RE: **10800 Gibson SE (SSTP)**
Grading and Drainage Plan
Engineer's Stamp Date: Signed, undated
Hydrology File: M21D007A1

Based on the information provided in the submittal received on 7/18/17, the Grading and Drainage Plan cannot be approved for grading or paving permit until the following comments are addressed:

GRADING &
DRAINAGE PLAN

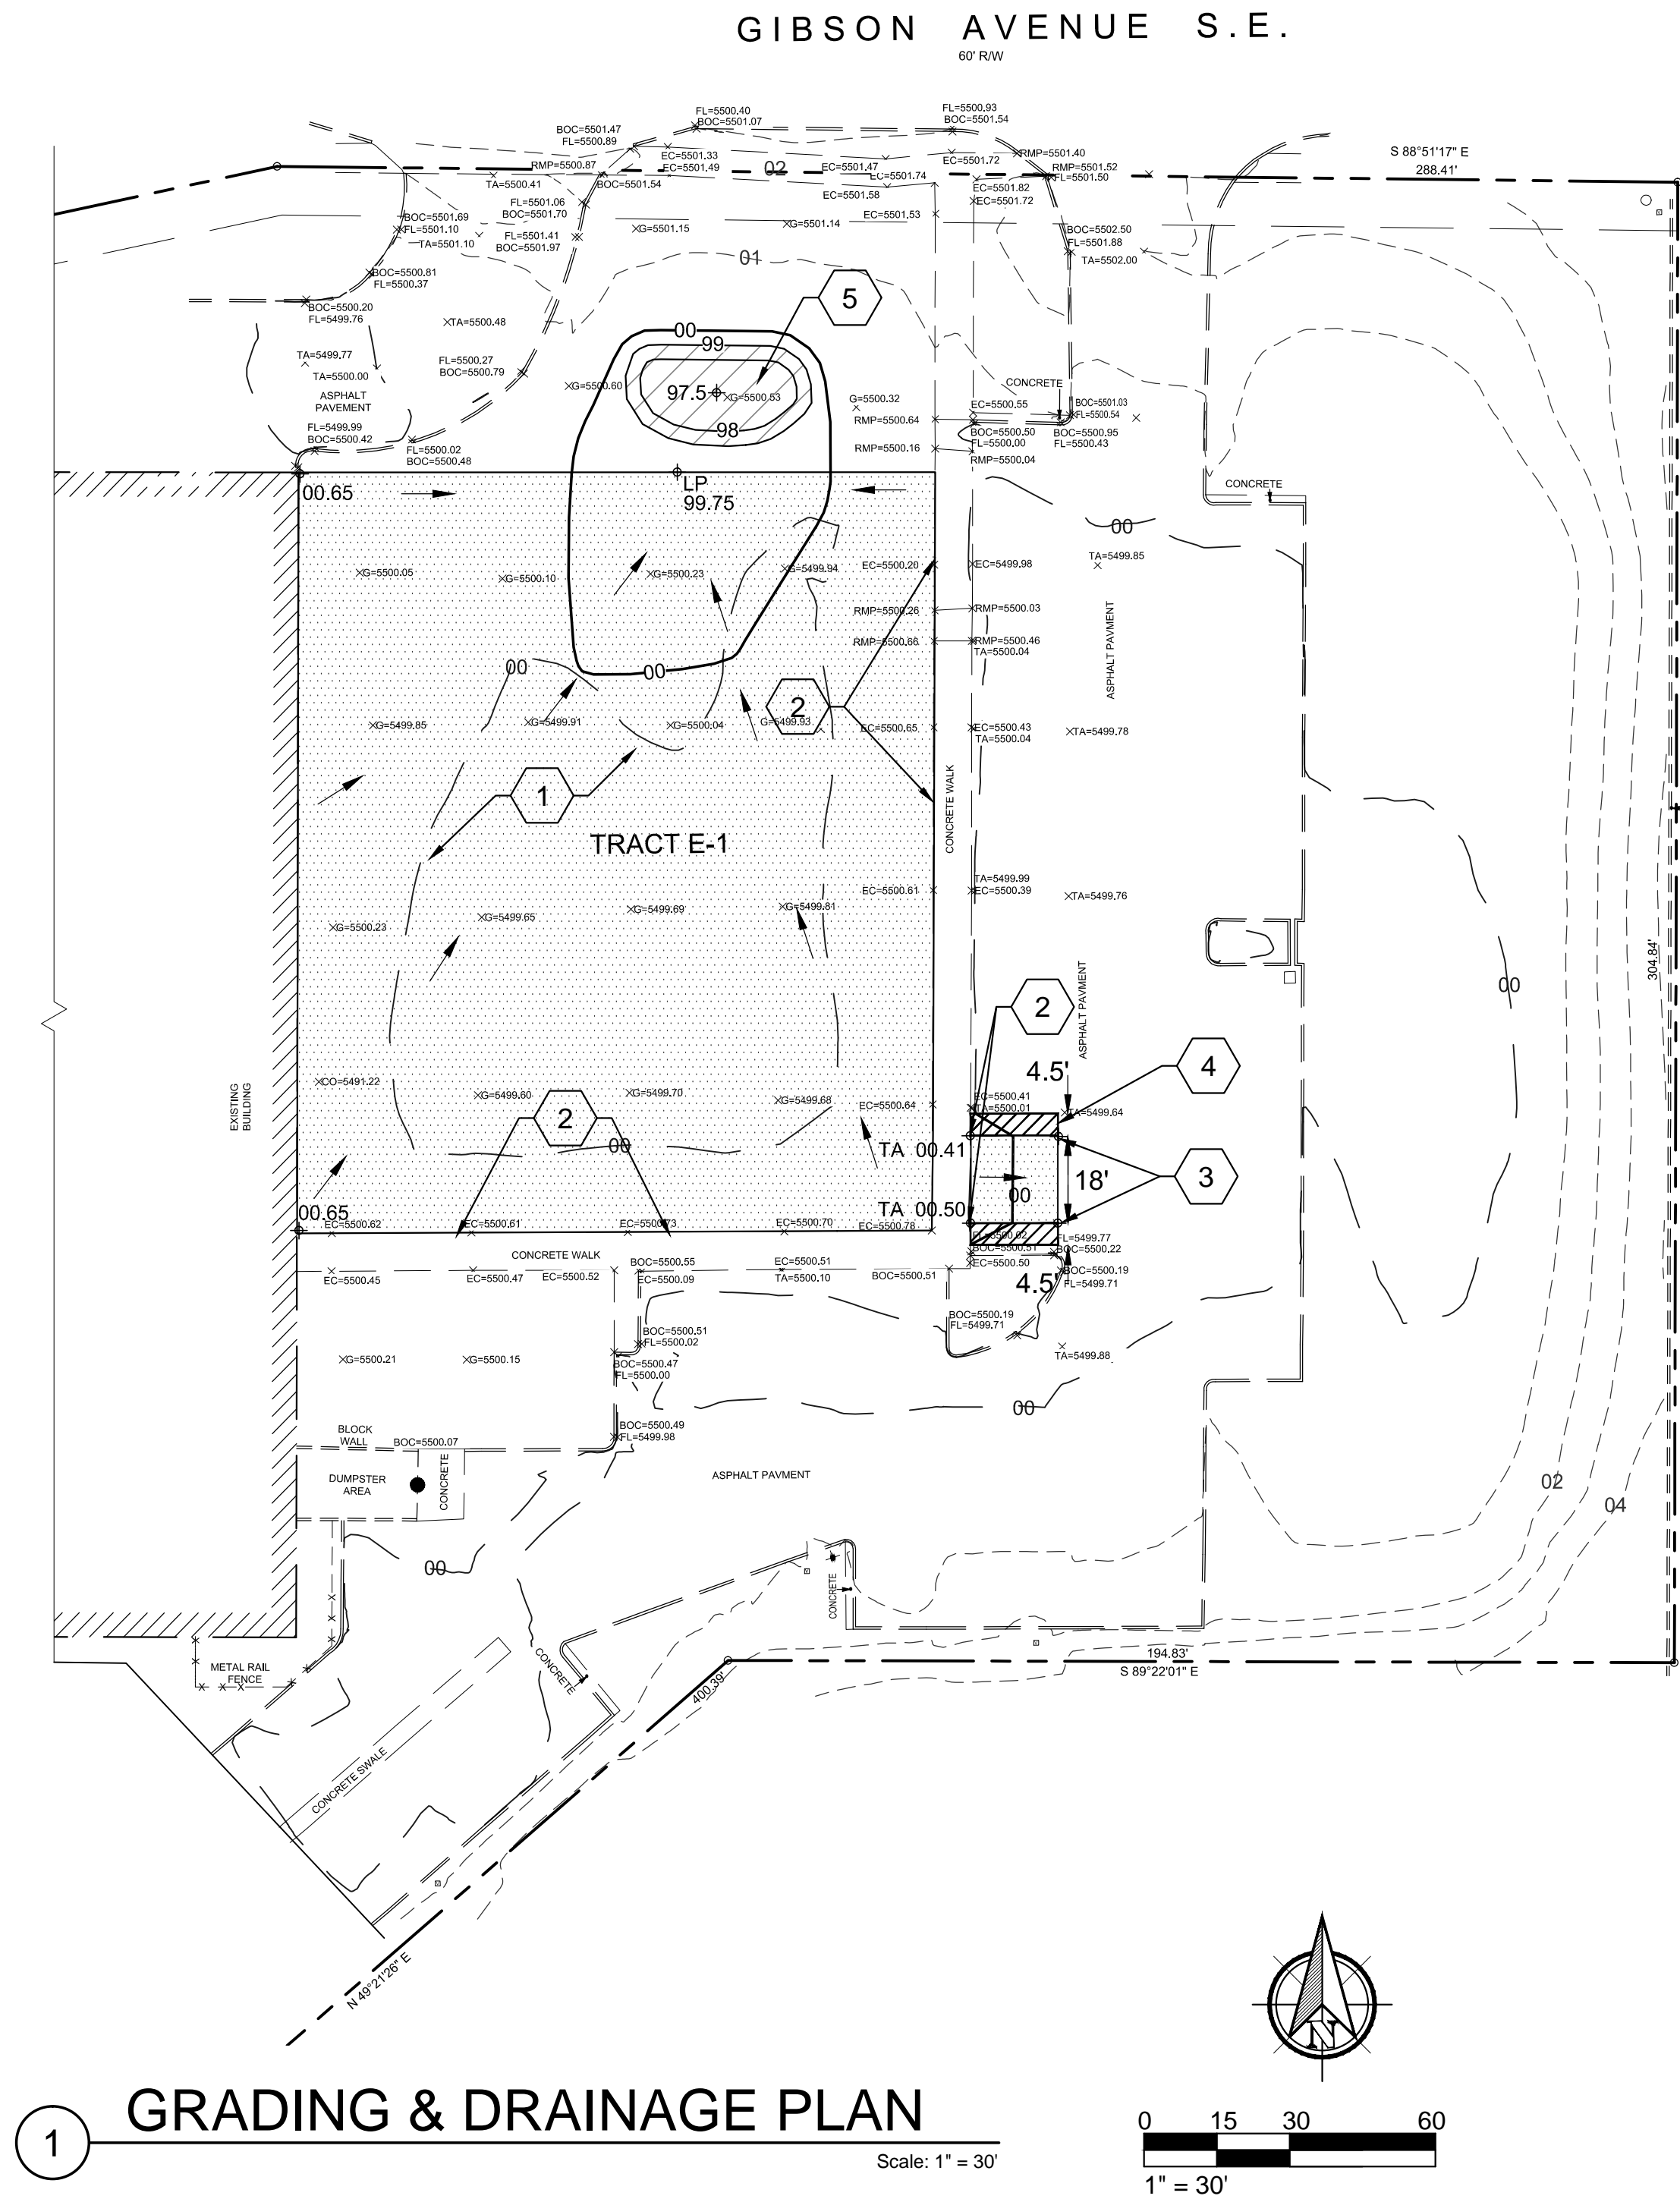
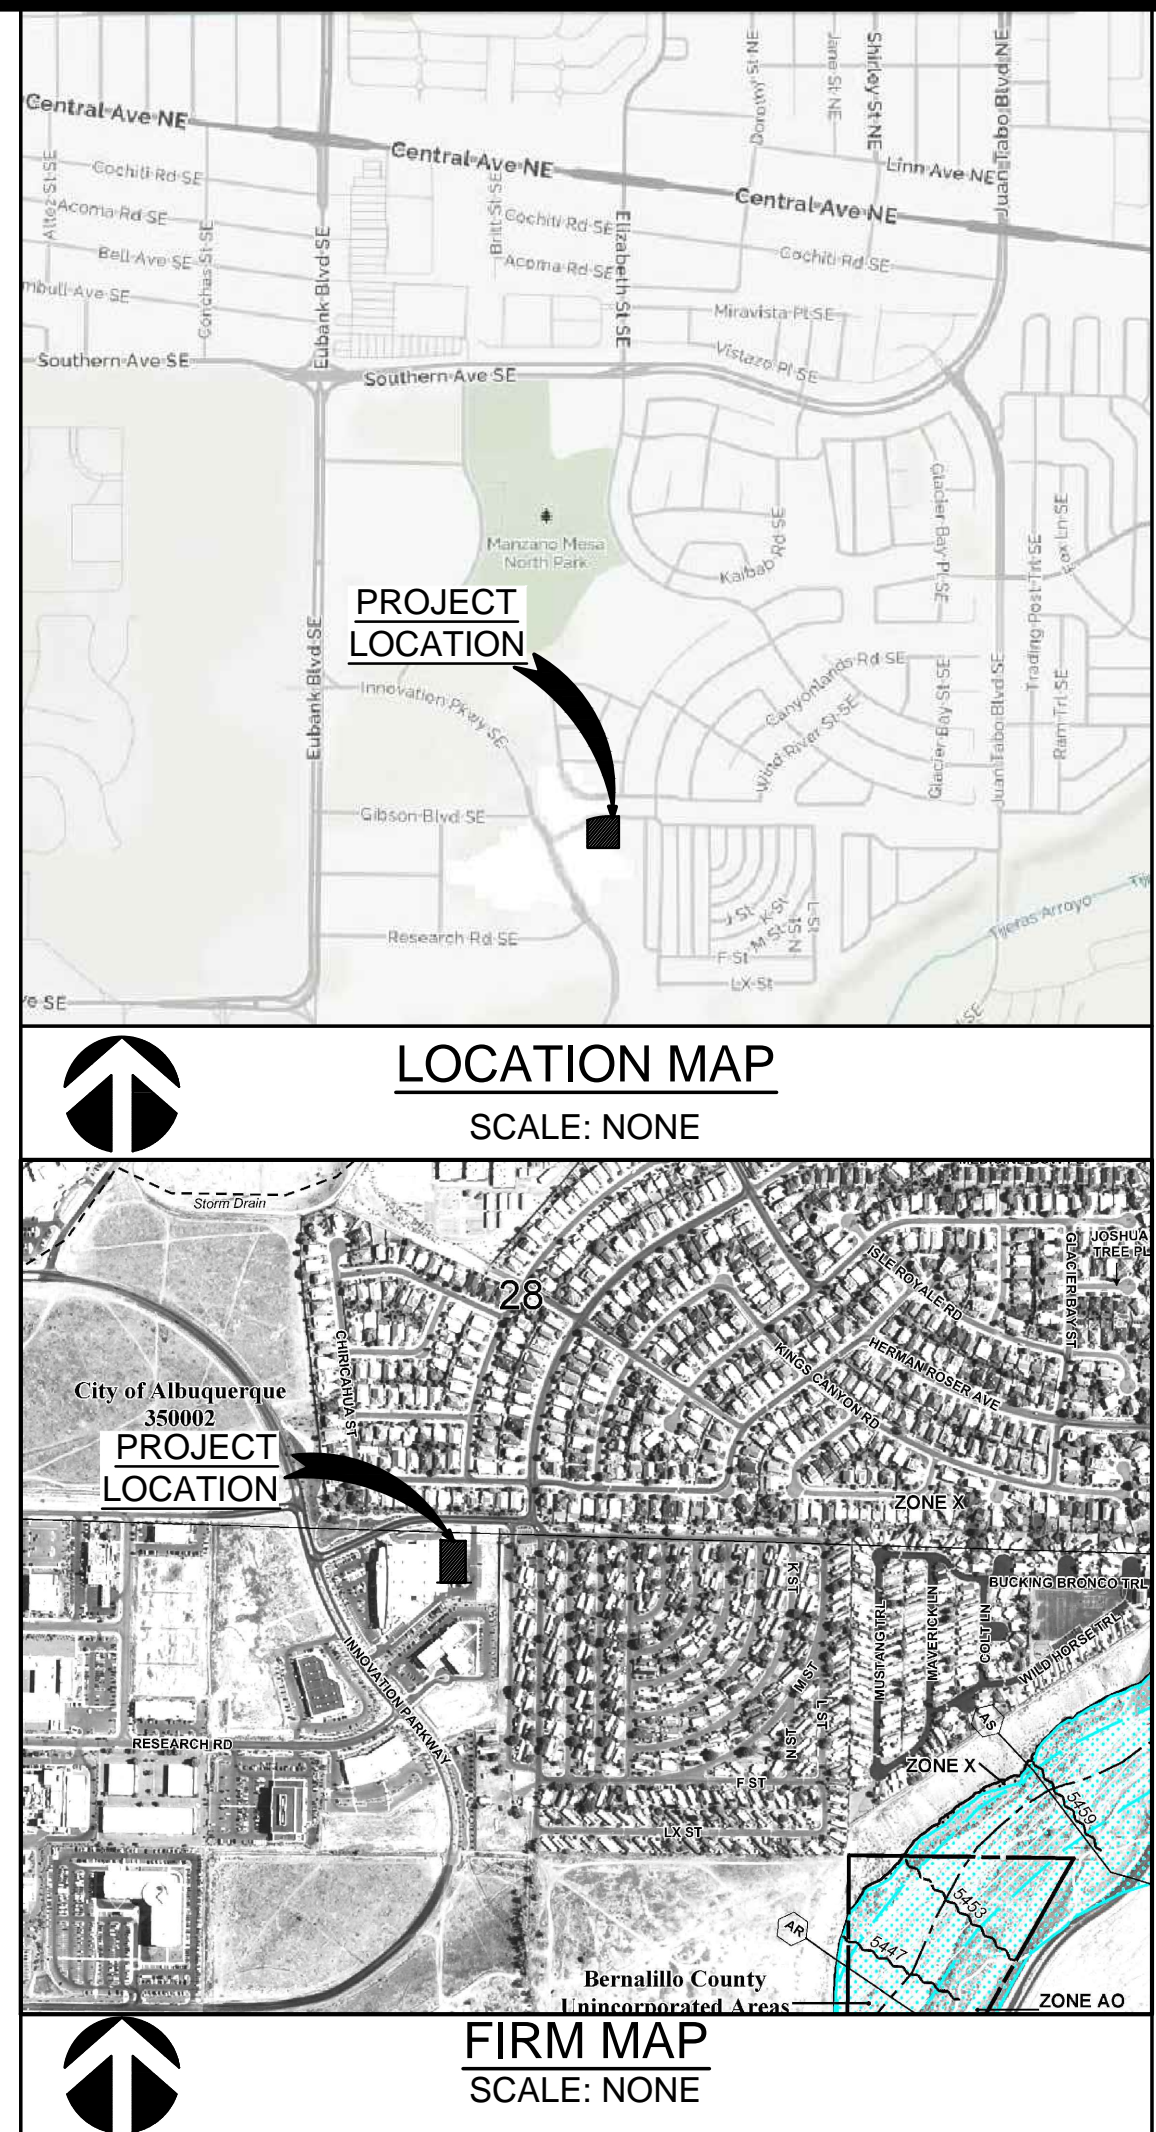
1. The drainage plan and narrative must demonstrate compliance with the approved Drainage Report (M21D007A1, prepared by ABQ Engineering, 7/25/05) and Drainage Master Plan (M21D007A, prepared by BHI, 9/12/01). If this grading and paving work changes the runoff or drainage pattern, adequate downstream capacity per § 14-5-2-12 (G) of the Albuquerque Code of Ordinances must be demonstrated for the new runoff and drainage pattern. If this cannot be demonstrated, the site will need to retain all additional runoff (100yr, 10day design storm).

2. First flush volume needs to be determined from: (0.44"-0.10") x impervious area. The required first flush volume for this site will be based on only the new impervious area.

3. Provide the finished floor elevation for the building. The finished floor should be 1' above existing grades.
4. What is the 100yr water surface elevation for the pond and where does it overflow? Ensure the pond overfilling won't affect the adjacent building.

5. Provide additional spot elevations (top of asphalt) and grades for the proposed parking area to ensure the site will be constructed to drain away from the building.

6. Valley gutter is recommended (but not required) along the flowline of the parking area.
7. A private facility drainage covenant is required for the pond (see attached). Once filled out, this document will need to be turned in to Madeline Carruthers (mtafoya@cabq.gov, 4th floor, Plaza del Sol) for signature routing.
8. Date the plan. Hydrology tracks submittals and resubmittals by the Engineer's stamp date.
9. Request paving permit approval on the DTIS when resubmitting, Hydrology can approve for Grading and Paving Permit concurrently for no additional cost.
10. Only one hardcopy (and one pdf) is required for Hydrology submittals.
